# UNITED STATES PATENT AND TRADEMARK OFFICE

<b>Office Action Summary</b>	<b>Application No.</b> 10/582,046	<b>Applicant(s)</b> STROBEL, GUSTAV	
	<b>Examiner</b> Joshua Rodden	<b>Art Unit</b> 3637

### DETAILED ACTION

Annotated Figure 3 (Weldner)

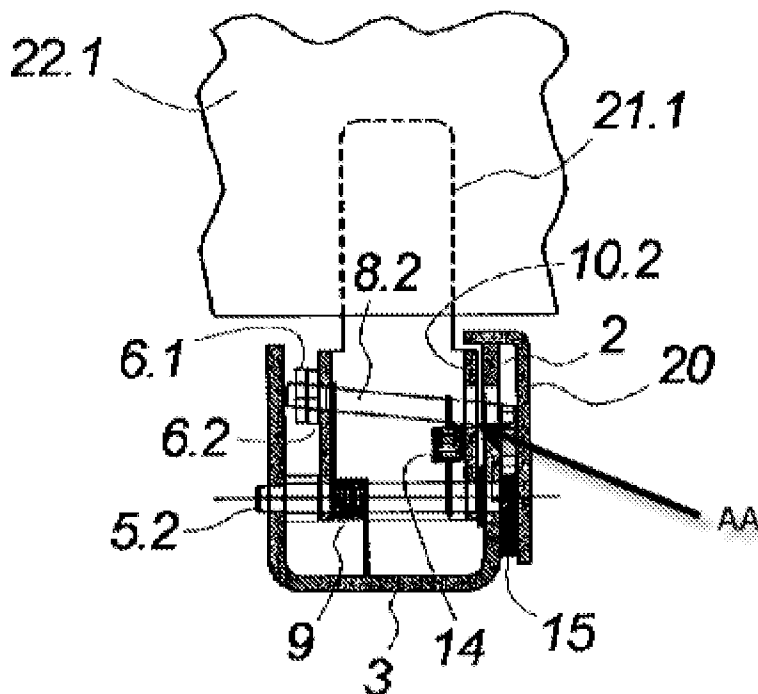
**7. Claims 13 and 18-22 are rejected under 35 U.S.C. 102(b) as being anticipated by EP 1340697 (Weldner).**

Regarding **Claims 13 and 18-22**, **Weldner** teaches: **Claim 13** – a stacking column comprising two side walls (2) and latches (21.1-21.3) arranged between the side

walls (2) on a pin (5.1-5.3) for rotation between a rest position into a working position, wherein the latches (21.1-21.3) are assigned a locking device (6.1-6.3, 8.1-8.3, 12.1-12.4 and 13.1-13.4) which fixes at least some of the latches (21.1-21.3) in the working position, (Figures 3 and 4); **Claim 18 (Dependent upon Claim 12)** – wherein a supporting part (10.1-10.4) is provided downstream of the pin holder on the latch (21.1), (Figure 3); **Claim 19** - wherein the supporting part (10.1-10.4) has a cutout (AA) for receiving part of the locking device (8.2), (Annotated Figure 3 Below); **Claim 20** – wherein a stop lug (10.2) projects from the upper part of the cutout (AA) to stop part of the locking device (8.2) from leaving the cutout (AA), (Annotated Figure 3); **Claim 21** – wherein the locking device (8.2) moves (between slots portions 12.4 and 13.4) in the cutout (AA) by means of a small rail (8.2), (Figure 4 and Annotated Figure 3); **Claim 22** – wherein the small rail (8.1-8.4) is part of a lever linkage (6.1-6.4) which moves in the manner of a “parallelogram” and similarly to the applicants device as seen in applicants Figures 1-7, (Figures 3 and 4).

Annotated Figure 1 (Scholler)

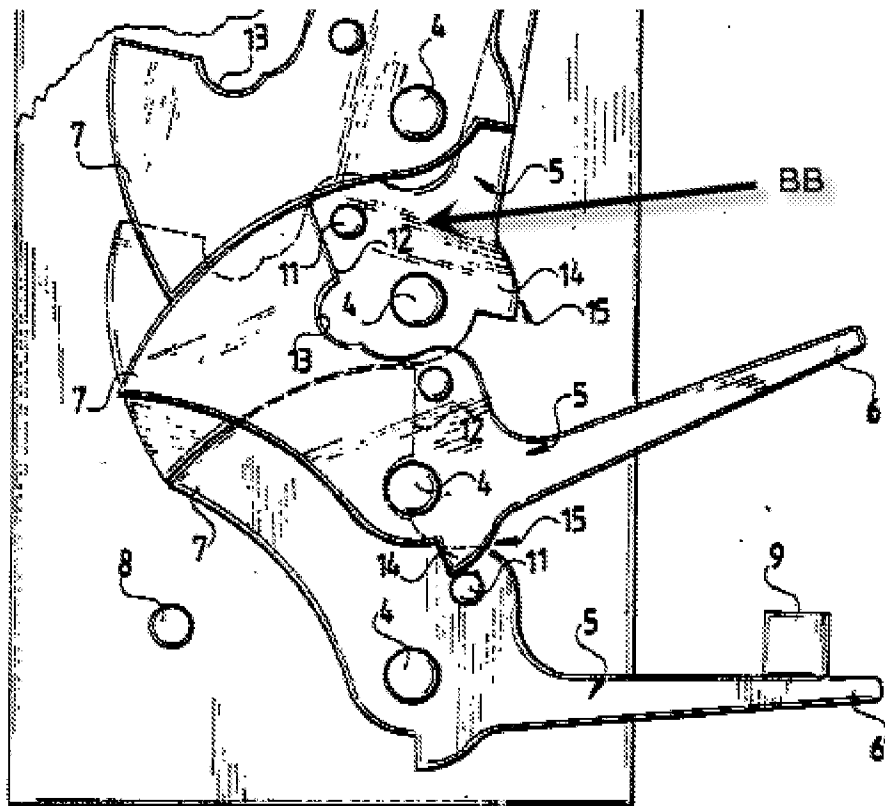
**10. Claims 12, and 14-18 are rejected under 35 U.S.C. 103(a) as being unpatentable over DE Patent No. 3811310 (Scholler) in view of U.S. patent no. 5,373,756 (Schoeller).**

Regarding **Claims 12 and 14-18, Scholler** teaches: **Claim 12** – a stacking column comprising two side walls (2 and 3) and latches (5) arranged between the side walls (2 and 3) on a pin (4) for rotation between a rest position into a working position, wherein at least some of the latches (5) have a pin holder surrounding the pin (4), (Figures 1 and 2); **Claim 14** – wherein at least two adjacent pins (4) maintain a distance from each other which is greater than and substantially the same as a material thickness (BB) of the latch (5) in the region (BB) of the pin holder, (Annotated Figure 1 Below); **Claim 15** – wherein the latch (5) is of a single piece design, (Figures 1 and 2); **Claim 16** – wherein a driver (7 and 12) protrudes from each of the latches (5) downstream of the pin holder, and when the latches rotate about the pin (4), the driver (7 and 12) acts on an adjacent latch (5) to move the latch (5) into a standby position, (Figure 1); **Claim 17** – wherein the drivers (7 and 12) of successfully following latches (5) are arranged in an alternating manner in the vicinity of respectively opposed side walls (2 and 3), (Figures 1 and 2); **Claim 18** – wherein the supporting part (6) is provided downstream of the pin holder, (Figure 1).

**Scholler** does not teach: wherein the latch has a pin holder which only partially surrounds the pin in an arcuately curved manner (**Claim 12**). However, **Schoeller** teaches: **Claim 12** - a latch (1) for use in a stacking column wherein the latch has a pin holder (5) which only partially surrounds a pin in an arcuatley curved manner, (Figure 1). Therefore, it would have been obvious to one of ordinary skill in the art to modify the stacking column of **Scholler** to have the latch having a pin holder which only partially surrounds the pin in an arcuately curved manner (**Claim 12**) as taught by **Schoeller** for the purpose of being able to easily replace a damaged latch.
